**FINAL FINDINGS AND DECISION BY THE DESIGN
COMMISSION RENDERED ON April 7, 2022**

**CASE FILE NUMBER: LU 21-108433 DZ – ARGYLE HOUSING
PC # 20-202695**

Type III Design Review for construction of approximately 290 residential units in an eleven-story building in the Kenton Plan District. The project site includes two parcels totaling 25,000 SF adjacent to the Kenton / North Denver Avenue MAX light rail station. The project includes main entrances along both street frontages, outdoor areas at the ground level and the rooftop, individual balconies, and common spaces through the building. A composite rain screen cladding is proposed above a concrete base with metal storefront systems at the ground level.

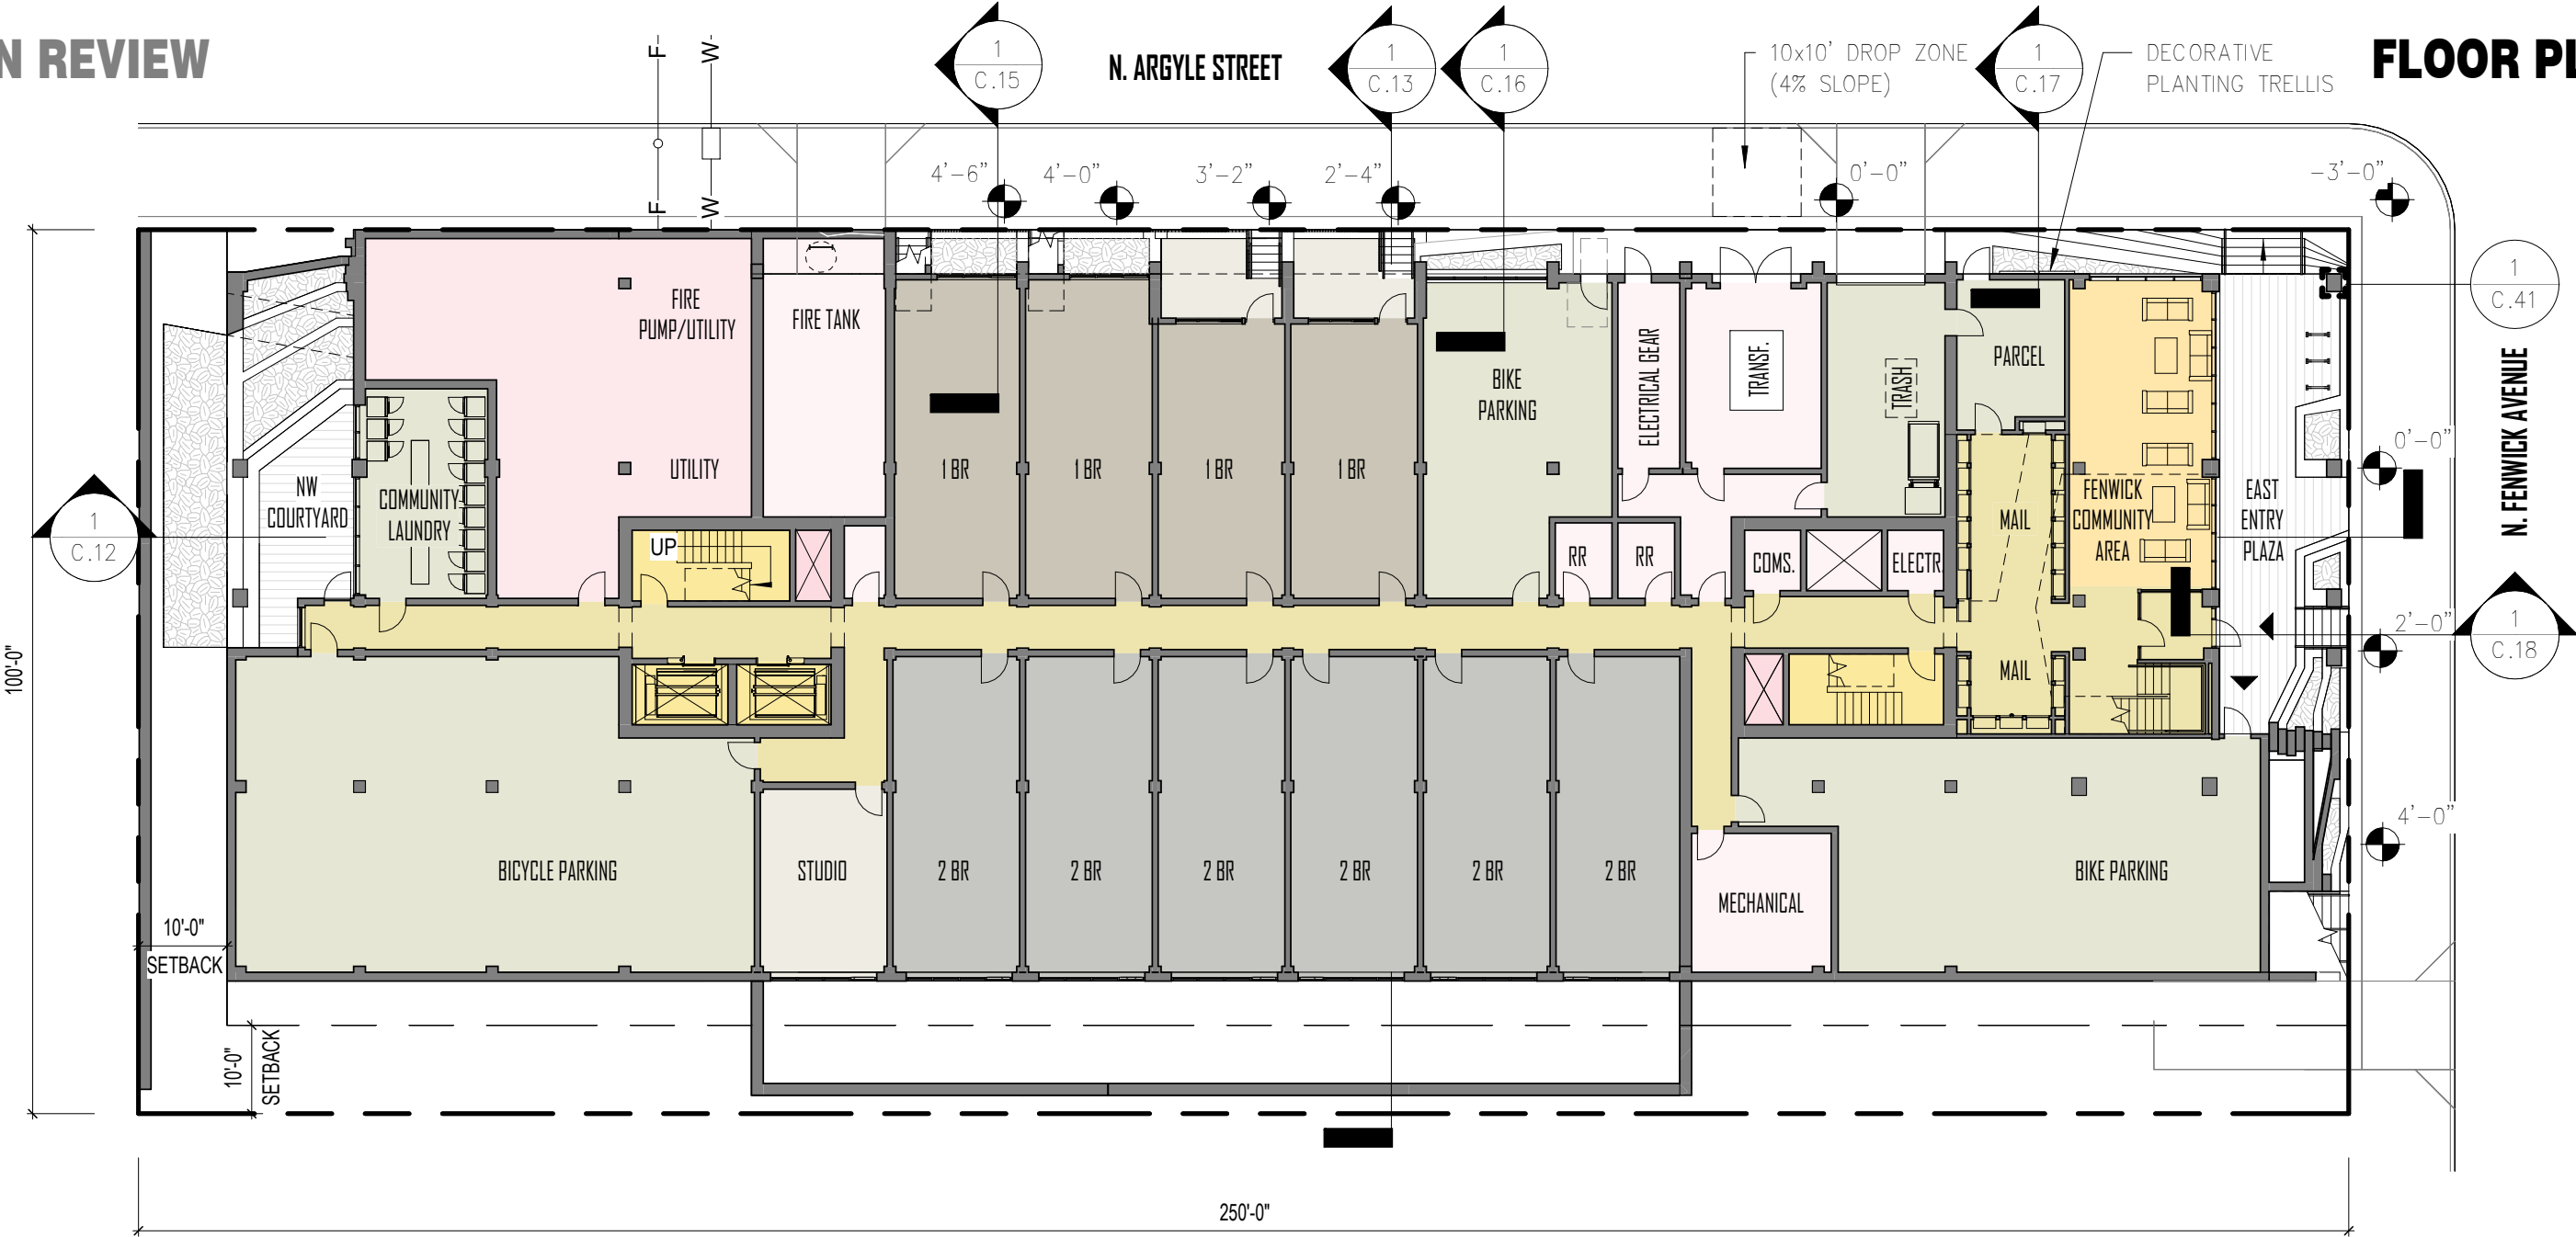
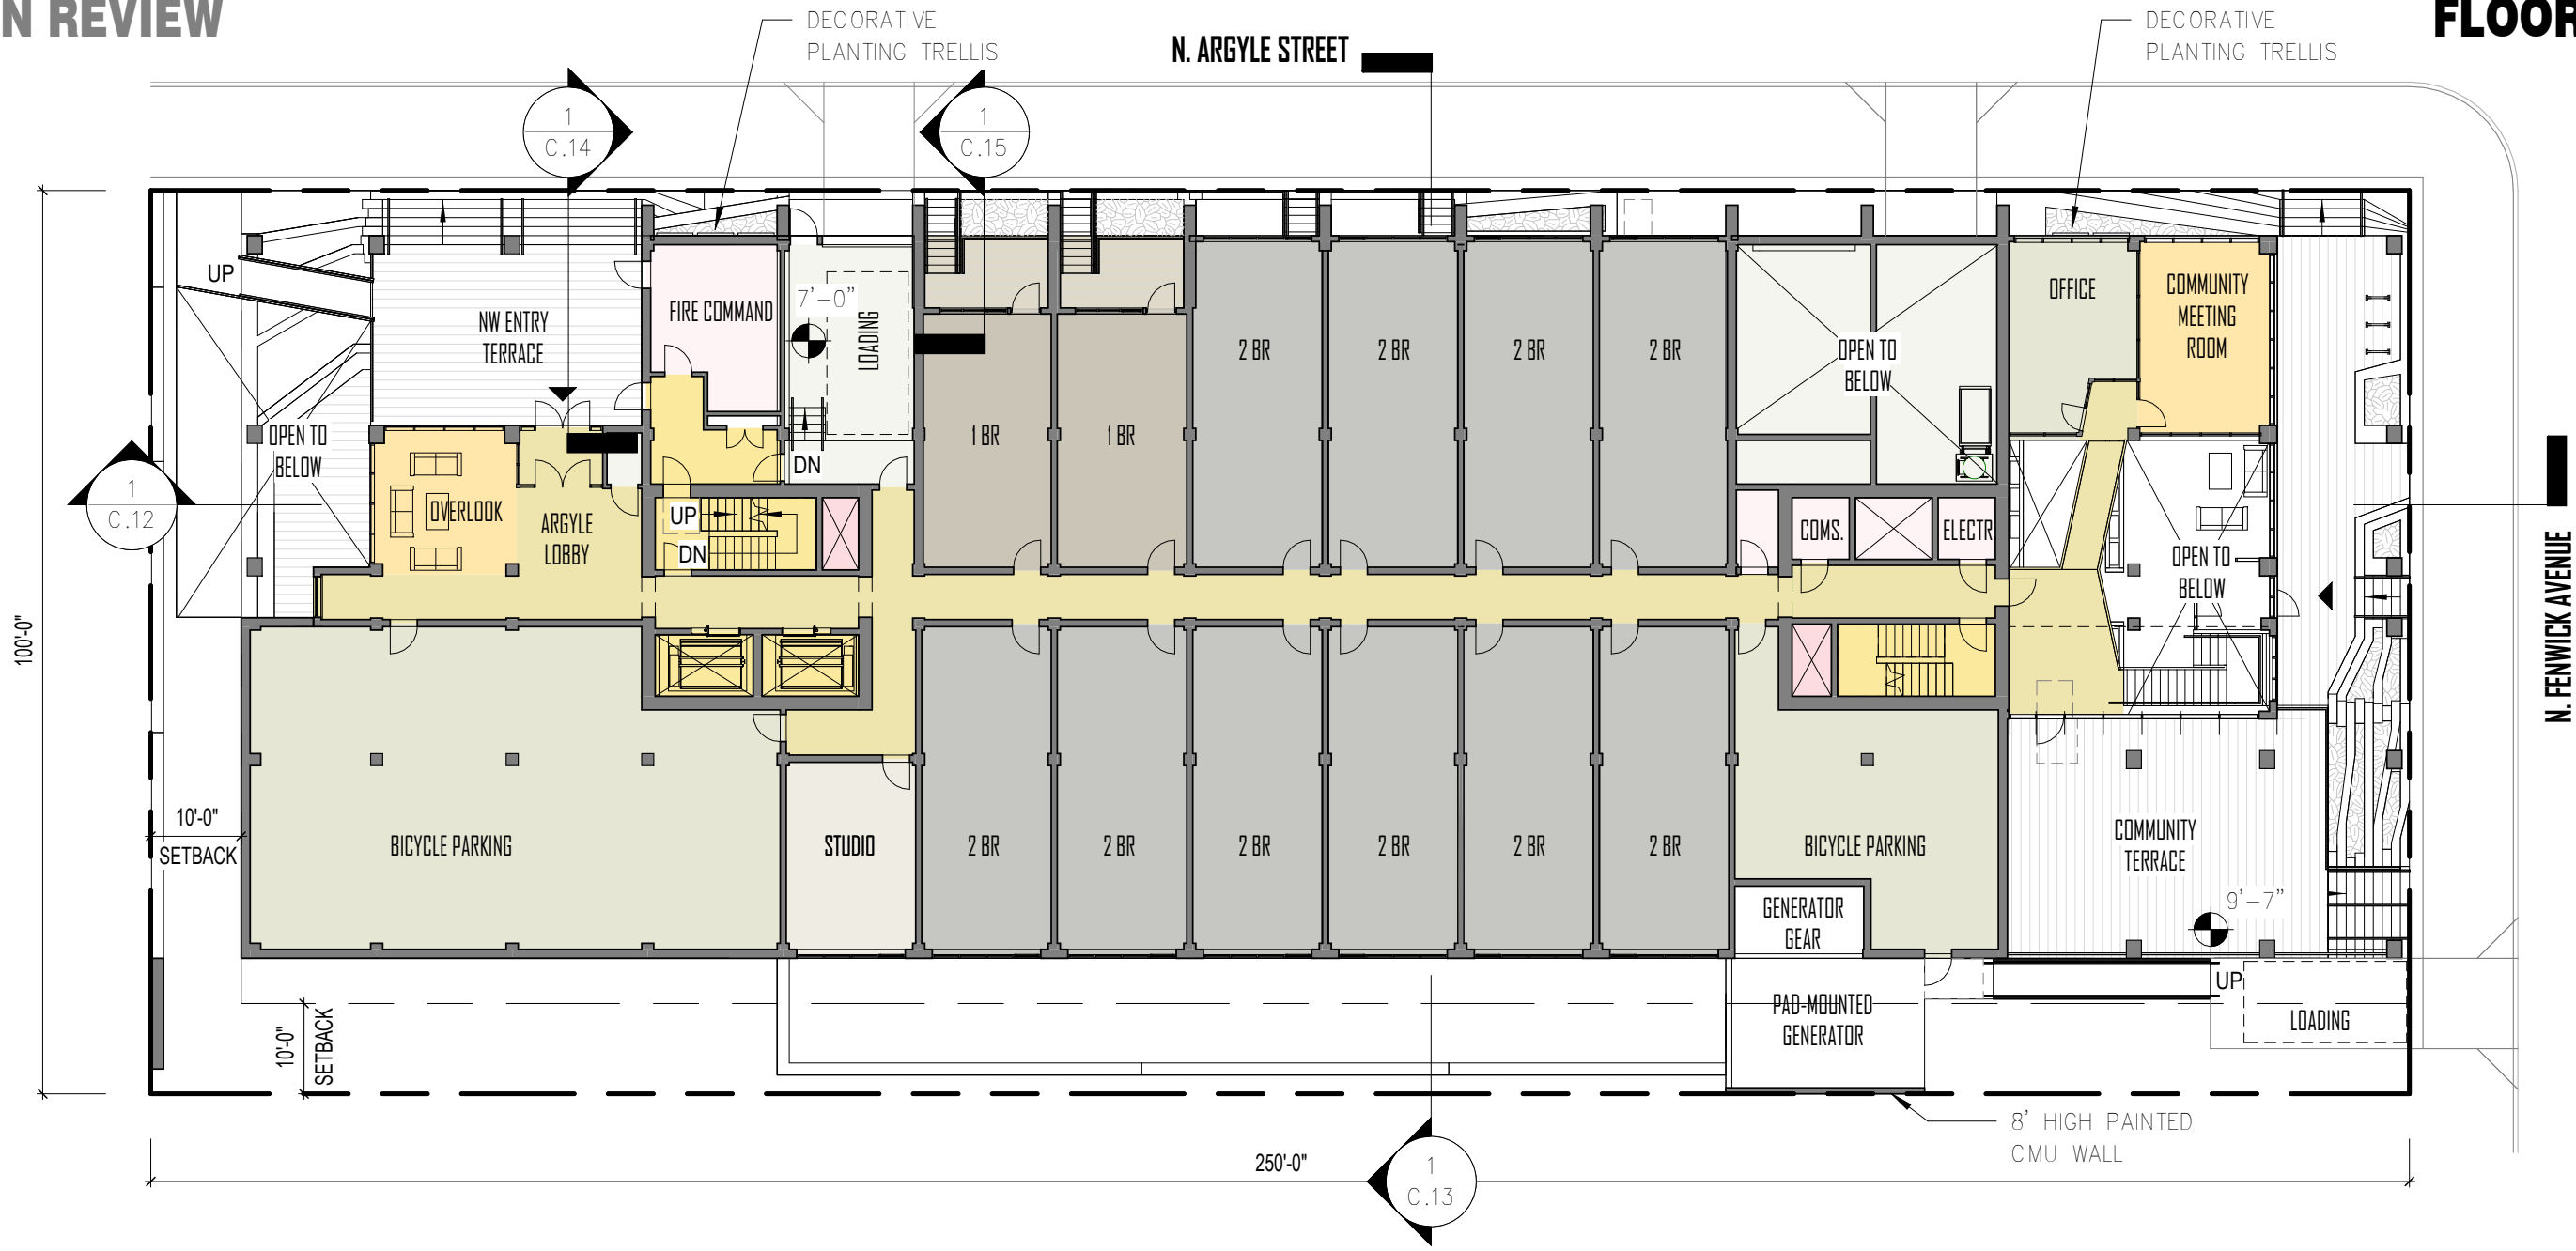
- 1. Ground Floor Units: Resolution of safety, comfort, design of at least two of the four ground floor dwelling units along Argyle.**
Response: The ground floor has been redesigned with the 2 deepest walk-down units replaced with 1 bd units that have half-height windows facing the street and a landscaping buffer for privacy. See sheets C.2, C.3, C.15
